Access Audit Site Report

Stephen F. Austin State Park

Accessibility Evaluation

Inspection Date: 08/18/2022

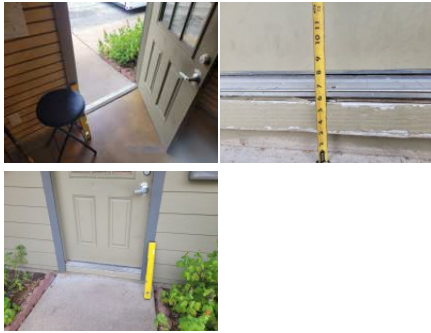
Finding Number	Area Description	Lat/Long	Finding	As Built	Recommendation	Citation	Photos	Figure
1	Headquarters Area: HQ - Parking	[29.8121045 , -96.1080327]	Element meets all standards and requirements	HQ Parking meets scoping requirements - 12 standard, 1 accessible	None	2010 ADAS Section: N/A		
2	Headquarters Area: HQ - Parking	[29.8121127 , -96.1080716]	There are no van accessible parking stalls. 1 in every 6, minimum of one, required accessible stalls must be a van accessible stall. There are a total of 12 parking stalls in the parking lot that could be reasonably associated with this facility. There should be a minimum of 1 accessible stalls with a minimum of 1 being designed as van accessible.	Lacks van signage	Add van parking sign to 1 accessible stall and repaint stall and access aisle to 11' and 5' or 8' and 8'.	2015 ABAAS Section: F208.2, F208.2.4 2012 TAS Section: 208.2, 208.2.4 2010 ADAS Section: 208.2, 208.2.4

3	Headquarters Area: HQ - Parking	[29.8120871 , -96.108034]	The cross slopes (narrow dimension) and/or running slopes (long dimension) of the access aisle exceeds 2%. The running slope and the cross slope in an accessible parking stall and the access aisle must not exceed 2%.	11.8% in access aisle	Repair or correct slope of parking space and access aisle to max 2.08% in any direction.	2015 ABAAS Section: 502.4 2012 TAS Section: 502.4 2010 ADAS Section: 502.4

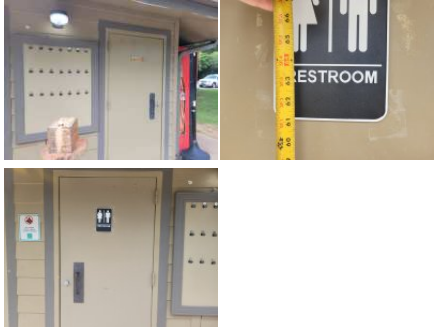
Finding Number	Area Description	Lat/Long	Finding	As Built	Recommendation	Citation	Photos	Figure
7	Headquarters Area: HQ - Public Spaces	[29.8119793 , -96.108071]	Minimum maneuvering clearances at doors and gates shall comply with 404.2.4. Maneuvering clearances shall extend the full width of the doorway and the required latch side or hinge side clearance. Maneuvering clearances shall have a max slope of 2.08%. Exterior doors are recommended to be maintained at 8.5 lbf as a smart practice. Force is to be measured at the operating hardware or 30 inches from the hinges, whichever is greater.	Store entry - 2.7% pull clearance, 14 lbf, door doesn't open to 90 degrees due to slope on interior	For all doors along the public circulation route, provide required maneuvering clearance on push and pull side of doors. For all doors along the public circulation route, correct slope in door clearance to max 2.08%. For all doors along the public circulation route, inspect, adjust, and maintain 8.5 lbf to open exterior doors as a smart practice.	2010 ADAS Section: 404.2.3, 404.2.7, 404.2.4, 404.2.11, 404.2.11 Exception

8	Headquarters Area: HQ - Public Spaces	[29.8119809 , -96.1080734]	The route of travel at this location does not provide a minimum width of 36 inches. The clear width shall be permitted to be reduced to 32 inches minimum for a length of 24 inches maximum provided that reduced width segments are separated by segments that are 48 inches long minimum and 36 inches wide minimum.	Reduces between some merchandise	Relocate merchandise to provide 36" clear width.	2015 ABAAS Section: 403.5.1 2012 TAS Section: 403.5.1 2010 ADAS Section: 403.5.1		
9	Headquarters Area: HQ - Public Spaces	[29.8119814 , -96.1080716]	The transaction counter is too high. A portion of the counter surface that is 36 inches long minimum and 36 inches high maximum above the finish floor shall be provided. Knee and toe space must be provided for a forward approach. A 30 inch by 48 inch clear floor space on an accessible route must be provided for either a forward or parallel approach.	Service counter 43" AFF	Lower 36" wide segment of service counter to max 36" AFF.	2015 ABAAS Section: 904.4.2, 904.4.1 2012 TAS Section: 904.4.1, 904.4.2 2010 ADAS Section: 904.4.2, 904.4.1

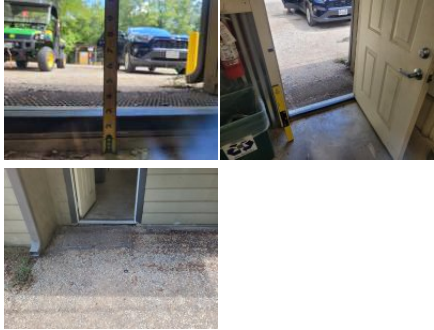
Finding Number	Area Description	Lat/Long	Finding	As Built	Recommendation	Citation	Photos	Figure
10	Headquarters Area: HQ - Public Spaces	[29.8118188 , -96.108059 6]	Element meets all standards and requirements	Benches comply	None	2010 ADAS Section: N/A		
11	Headquarters Area: HQ - Public Spaces	[29.8120098 , -96.107997 8]	Changes in level greater than ½ inch (13 mm) high shall be ramped, and shall comply with 405 or 406.	Lacks route to pay station, maps due to 2 - 6" changes in level	Create a curb ramp to be max running slope 8.33%, max cross slope 2.08%, having a top landing as wide as the ramp and 36" deep and side flares with a max slope 10% along the AR where curbs are present.	2015 ABAAS Section: 303.4 2012 TAS Section: 303.4 2010 ADAS Section: 303.4		
12	Headquarters Area: HQ - Public Spaces	[29.8119765 , -96.108050 4]	Element meets all standards and requirements	vending machine complies	None	2010 ADAS Section: N/A

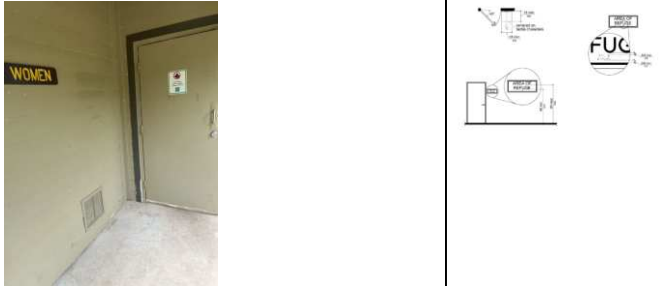
Finding Number	Area Description	Lat/Long	Finding	As Built	Recommendation	Citation	Photos	Figure
38	Day Use Area: Day Use - Men's Restroom	[29.8138132 , -96.112455 2]	The building entrance is not located on an accessible route. When a building, or portion of a building, is required to be accessible, an accessible route of travel shall be provided to all portions of the building, to accessible building entrances and between the building and the public way. All walks, halls, corridors, aisles, skywalks, tunnels, and other spaces that are part of an accessible route must comply. An accessible route of travel must not pass through kitchens, storage rooms, restrooms, closets or other spaces used for similar purposes. At least one accessible route within the boundary of the site must be provided from public transportation stops, accessible parking and accessible passenger loading zones and public streets or sidewalks to the accessible building entrance they serve. The accessible route shall, to the maximum extent feasible, coincide with the route for the general public. At least one accessible route shall connect accessible buildings, facilities, elements and spaces that are on the same site. At least one accessible route shall connect accessible building or facility entrances with all accessible spaces and elements.	Lacks route to restroom building	Create AR with crushed and compacted stone or similar outdoor material from parking or sidewalk to building entrance.	2015 ABAAS Section: F206.2.1 2012 TAS Section: 206.2.1 2010 ADAS Section: 206.2.1

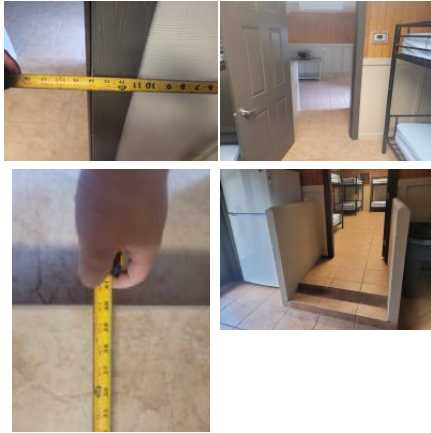
Finding Number	Area Description	Lat/Long	Finding	As Built	Recommendation	Citation	Photos	Figure
73	Bullinger Creek Group Lodge: Bullinger Creek - Lodge	[29.81488, -96.1105]	The mirror is mounted too high. Mirrors must have the bottom edge of the reflecting surface a maximum of 40 inches above the floor if above a sink or counter. Mirrors not located above lavatories or countertops shall be installed with the bottom edge of the reflecting surface 35 inches maximum above the finish floor or ground.	accessible room restroom- mirror 41.5" AFF	Lower mirror so bottom reflective surface is max 40" AFF and 74" at the top.	2015 ABAAS Section: 603.3 2012 TAS Section: 603.3 2010 ADAS Section: 603.3		
74	Bullinger Creek Group Lodge: Bullinger Creek - Lodge	[29.81488, -96.1105]	The accessible route contains running slopes greater than 5 percent and cross slopes greater than 2 percent across the width of the walk and has not been constructed as a ramp (i.e. handrails, wheel guides, etc.). When the slope in the direction of travel of any walk exceeds 1 unit vertical in 20 units horizontal (5-percent slope), it must be constructed as ramp. Surface cross slopes must not exceed one unit vertical in 48 units. Horizontal (2-percent slope).	accessible room restroom- slopes up to 3.9% at drains	Correct or repair slope to max 2.08% in restroom.	2015 ABAAS Section: 403.3 2012 TAS Section: 403.3 2010 ADAS Section: 403.3

75	Bullinger Creek Group Lodge: Bullinger Creek - Lodge	[29.81488, -96.1105]	The top rim of the sink is too high. All lavatories/sinks that are designated to be accessible shall be a minimum 17 inches in horizontal depth and mounted with the rim or counter edge no higher than 34 inches above the finished floor.	accessible room restroom- sink 34.5" AFF	Lower sinks to max 34" above the finished floor (AFF) to front of rim.	2015 ABAAS Section: 606.3 2012 TAS Section: 606.3 2010 ADAS Section: 606.3

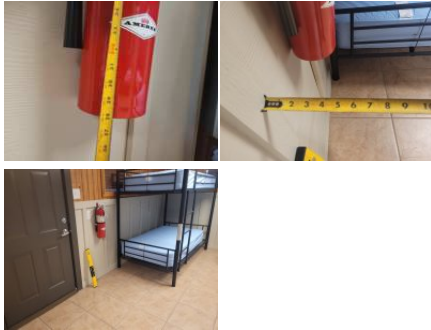
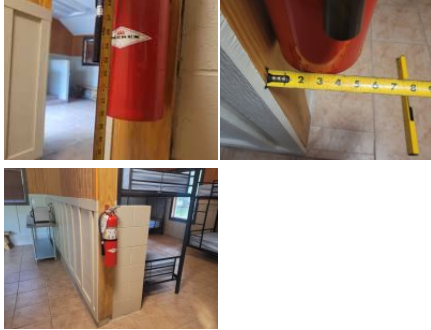
Finding Number	Area Description	Lat/Long	Finding	As Built	Recommendation	Citation	Photos	Figure
76	Bullinger Creek Group Lodge: Bullinger Creek - Lodge	[29.81488, -96.1105]	Where a high forward reach is over an obstruction, the clear floor space shall extend beneath the element for a distance not less than the required reach depth over the obstruction. The high forward reach shall be 48 inches (1220 mm) maximum where the reach depth is 20 inches (510 mm) maximum. Where the reach depth exceeds 20 inches (510 mm), the high forward reach shall be 44 inches (1120 mm) maximum and the reach depth shall be 25 inches (635 mm) maximum. Where a clear floor or ground space allows a parallel approach to an element and the high side reach is over an obstruction, the height of the obstruction shall be 34 inches (865 mm) maximum and the depth of the obstruction shall be 24 inches (610 mm) maximum. The high side reach shall be 48 inches (1220 mm) maximum for a reach depth of 10 inches (255 mm) maximum. Where the reach depth exceeds 10 inches (255 mm), the high side reach shall be 46 inches (1170 mm) maximum for a reach depth of 24 inches (610 mm) maximum.	accessible room restroom- soap 49" AFF and over counter, both light switches 55" AFF	Lower operating mechanisms to max 48" above the finished floor (AFF) to highest operable part. Lower to max 44" above the finished floor (AFF) for a forward reach over counter.	2015 ABAAS Section: 308.2.1, 308.3.2 2012 TAS Section: 308.2.1, 308.3.2 2010 ADAS Section: 308.2.1, 308.3.2

77	Bullinger Creek Group Lodge: Bullinger Creek - Lodge	[29.81488, -96.1105]	The rear grab bar is not 36" long or is not mounted in the correct location. The rear grab bar must be a minimum of 36" long and extend from the toilet centerline a minimum 12" towards the wall side and a minimum 24" towards the open side of the toilet. Grab bars shall be installed in a horizontal position, 33 inches minimum and 36 inches maximum above the finish floor measured to the top of the gripping surface and the space between the grab bar and the top of the tank shall be 1-1/2 inches minimum.	accessible room restroom- rear bar 11" to wall side	Remount rear grab bar to behind the toilet, 12" to the wall side of center and 24" to the open side and 33" to 36" AFF.	2015 ABAAS Section: 604.5.2 2012 TAS Section: 604.5.2 2010 ADAS Section: 604.5.2

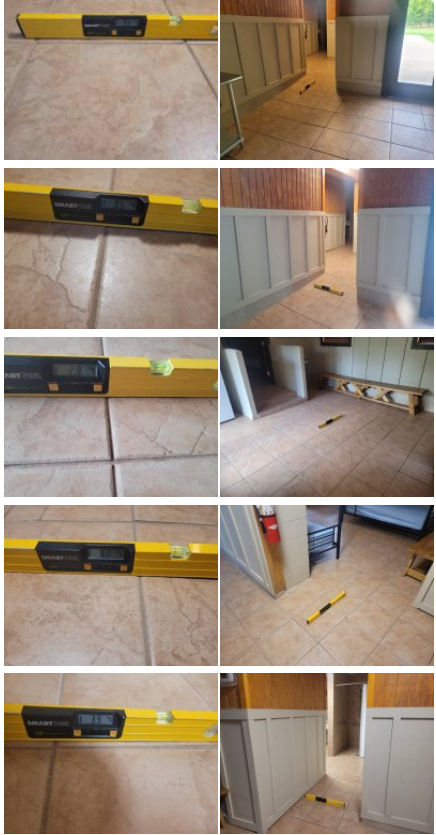
Finding Number	Area Description	Lat/Long	Finding	As Built	Recommendation	Citation	Photos	Figure
78	Bullinger Creek Group Lodge: Bullinger Creek - Lodge	[29.81488, -96.1105]	The accessible route contains running slopes greater than 5 percent and cross slopes greater than 2 percent across the width of the walk and has not been constructed as a ramp (i.e. handrails, wheel guides, etc.). When the slope in the direction of travel of any walk exceeds 1 unit vertical in 20 units horizontal (5-percent slope), it must be constructed as ramp. Surface cross slopes must not exceed one unit vertical in 48 units. Horizontal (2-percent slope).	accessible room restroom- 2.5% in front of toilet	Correct or repair slope to max 2.08% in restroom.	2015 ABAAS Section: 403.3 2012 TAS Section: 403.3 2010 ADAS Section: 403.3		
79	Bullinger Creek Group Lodge: Bullinger Creek - Lodge	[29.81488, -96.11048]	Transfer type shower compartments shall be 36 inches (915 mm) by 36 inches (915 mm) clear inside dimensions measured at the center points of opposing sides and shall have a 36 inch (915 mm) wide minimum entry on the face of the shower compartment. Clearance of 36 inches (915 mm) wide minimum by 48 inches (1220 mm) long minimum measured from the control wall shall be provided.	accessible room restroom- shower 36.5" wide	Correct transfer shower to compliant 36" by 36" clear inside dimension.	2015 ABAAS Section: 608.2.1 2012 TAS Section: 608.2.1 2010 ADAS Section: 608.2.1

80	Bullinger Creek Group Lodge: Bullinger Creek - Lodge	[29.81488, -96.11048]	Shower controls are in the incorrect location In transfer type shower compartments, the controls, faucets, and shower spray unit shall be installed on the side wall opposite the seat 38 inches (965 mm) minimum and 48 inches (1220 mm) maximum above the shower floor and shall be located on the control wall 15 inches (380 mm) maximum from the centerline of the seat toward the shower opening.	accessible room restroom- handheld mount closer to back wall, diverter 53" AFF	Remount shower controls to the correct location in the transfer shower.	2015 ABAAS Section: 608.5.1 2012 TAS Section: 608.5.1 2010 ADAS Section: 608.5.1

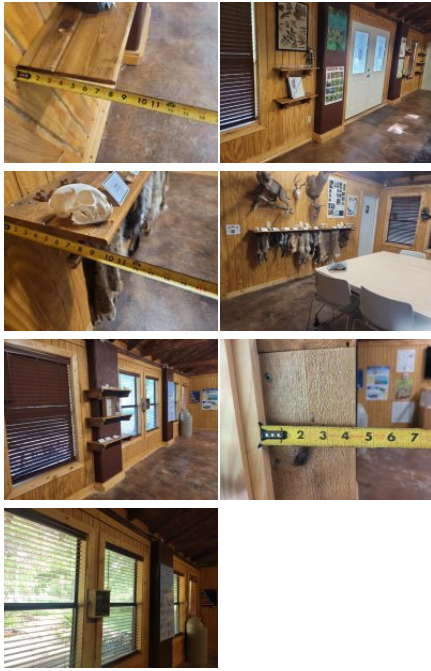
Finding Number	Area Description	Lat/Long	Finding	As Built	Recommendation	Citation	Photos	Figure
126	Bullinger Creek Group Lodge: Bullinger Creek - Dining/Rec Hall	[29.815146, -96.110817 2]	The accessible path of travel contains cross slopes greater than 2%. Surface cross slopes shall not exceed one unit vertical in 48 units horizontal (2-percent slope). When the slope in the direction of travel of any walk exceeds 1 unit vertical in 20 units horizontal (5-percent slope), it must be constructed as ramp.	kitchen- 2.4% near drain	Correct or repair cross slope of AR to max 2.08%.	2015 ABAAS Section: F206.2.4, 403.3 2012 TAS Section: 206.2.4, 403.3 2010 ADAS Section: 206.2.4, 403.3		
127	Bullinger Creek Group Lodge: Bullinger Creek - Dining/Rec Hall	[29.8151452, -96.110836 4]	Element meets all standards and requirements	Entry doors to dining/rec hall comply	None	2010 ADAS Section: N/A		
128	Bullinger Creek Group Lodge: Bullinger Creek - Dining/Rec Hall	[29.815139, -96.110716]	There is no accessible route to the table. At least one accessible route shall connect accessible buildings, accessible facilities, accessible elements, and accessible spaces that are on the same site.	Lacks route to table	Create an accessible route with crushed stone or other outdoor material from parking or walkway to the table.	2015 ABAAS Section: F206.2.2 2012 TAS Section: 206.2.2 2010 ADAS Section: 206.2.2

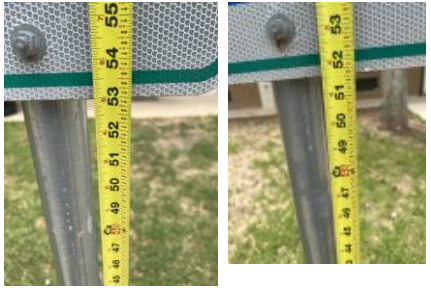
Finding Number	Area Description	Lat/Long	Finding	As Built	Recommendation	Citation	Photos	Figure
234	Campsites with Water (along Ironwood Trail): Campsites Water-Family Restroom Women's Side	[29.8184624 , -96.109139]	Where a high forward reach is over an obstruction, the clear floor space shall extend beneath the element for a distance not less than the required reach depth over the obstruction. The high forward reach shall be 48 inches (1220 mm) maximum where the reach depth is 20 inches (510 mm) maximum. Where the reach depth exceeds 20 inches (510 mm), the high forward reach shall be 44 inches (1120 mm) maximum and the reach depth shall be 25 inches (635 mm) maximum. Where a clear floor or ground space allows a parallel approach to an element and the high side reach is over an obstruction, the height of the obstruction shall be 34 inches (865 mm) maximum and the depth of the obstruction shall be 24 inches (610 mm) maximum. The high side reach shall be 48 inches (1220 mm) maximum for a reach depth of 10 inches (255 mm) maximum. Where the reach depth exceeds 10 inches (255 mm), the high side reach shall be 46 inches (1170 mm) maximum for a reach depth of 24 inches (610 mm) maximum.	Soap 50.5" AFF (new restroom)	Lower operating mechanisms to max 48" above the finished floor (AFF) to highest operable part.	2015 ABAAS Section: 308.2.1, 308.3.2 2012 TAS Section: 308.2.1, 308.3.2 2010 ADAS Section: 308.2.1, 308.3.2

235	Campsites with Water (along Ironwood Trail): Campsites Water-Family Restroom Women's Side	[29.8184542 , -96.1091725]	The required 56 inches by 60 inches clear floor space for the water closet has been obstructed. The clear floor space around the water closet shall be 60 inches minimum measured perpendicular from the side wall and 56 inches minimum measured perpendicular from the rear wall.	Garbage can and floor sign in toilet clearance	Relocate storage to provide required 60" clearance around toilet.	2015 ABAAS Section: 604.3. 2012 TAS Section: 604.3.1 2010 ADAS Section: 604.3.1

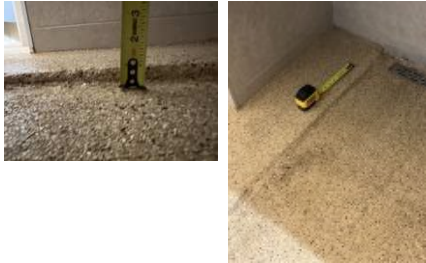
Finding Number	Area Description	Lat/Long	Finding	As Built	Recommendation	Citation	Photos	Figure
248	Full Hook-Up Campsites (RV loops): RV - Sample Campsite	[29.8206136 , -96.110755 6]	Camping facilities shall provide camping units with mobility features complying with F244.2 in accordance with Table F244.2. Where a camping facility provides different types of camping units, Table F244.2 shall apply to each type of camping unit provided. Total Number of Camping Units Provided in Camping Facility Minimum Number of Camping Units with Mobility Features Required 1 1 2 to 25 2 26 to 50 3 51 to 75 4 76 to 100 5 101 to 150 7 151 to 200 8 201 and over 8, plus 2 percent of the number over 200	0 of 38 campsites comply	Create the required number of accessible camp sites per table F244.2 as a smart practice.	2015 ABAAS Section: F244.2		
249	Full Hook-Up Campsites (RV loops): RV - Sample Campsite	[29.8206171 , -96.110762 3]	Parking spaces and pull-up spaces for recreational vehicles shall be 20 feet (6100 mm) wide minimum. EXCEPTION: Where two adjacent parking spaces are provided for recreational vehicles, one parking space shall be permitted to be 16 feet (4880 mm) wide minimum.	Site 30 - campsite parking fails; width, deterioration	Correct RV parking space to be 20' wide minimum; or 16' for two adjacent spaces as a smart practice.	2015 ABAAS Section: 1012.2, 1012.2 EXCEPTION

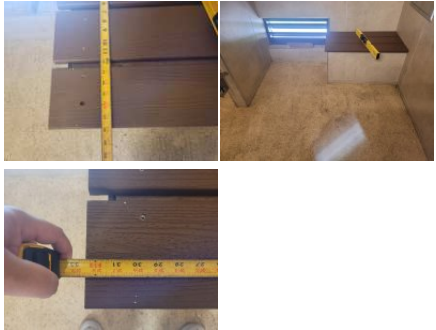
Finding Number	Area Description	Lat/Long	Finding	As Built	Recommendation	Citation	Photos	Figure
260	Full Hook-Up Campsites (RV loops): RV - Men's Restroom	[29.8210456 , -96.1110136]	There is a change in level greater than 1/4 inch. 1/4 inch is the maximum vertical rise. Changes in level between 1/4 inch and 1/2 inch must be beveled at 1:2 or less. Changes in level greater than 1/2 inch must be by way of a ramp.	1-1.5" CIL to drain	Repair, bevel or ramp CIL along accessible route (AR) to max .25".	2015 ABAAS Section: 303.3 2012 TAS Section: 303.3 2010 ADAS Section: 303.3		
261	Full Hook-Up Campsites (RV loops): RV - Men's Restroom	[29.8210631 , -96.1110377]	The accessible route contains running slopes greater than 5 percent and cross slopes greater than 2 percent across the width of the walk and has not been constructed as a ramp (i.e. handrails, wheel guides, etc.). When the slope in the direction of travel of any walk exceeds 1 unit vertical in 20 units horizontal (5-percent slope), it must be constructed as ramp. Surface cross slopes must not exceed one unit vertical in 48 units. Horizontal (2-percent slope).	3.1% at sink	Correct or repair slope to max 2.08% in restroom.	2015 ABAAS Section: 403.3 2012 TAS Section: 403.3 2010 ADAS Section: 403.3

262	Full Hook-Up Campsites (RV loops): RV - Men's Restroom	[29.8210488 , -96.1110292]	The baby changing table is not provided with a forward approach. Baby changing tables must be provided with a forward approach. Knee and toe clearance shall be provided.	Changing station in men's lacks knee clearance, 25.5" AFF	Provide knee and toe clearance at changing table	2015 ABAAS Section: 902.2 2012 TAS Section: 902.2 2010 ADAS Section: 902.2
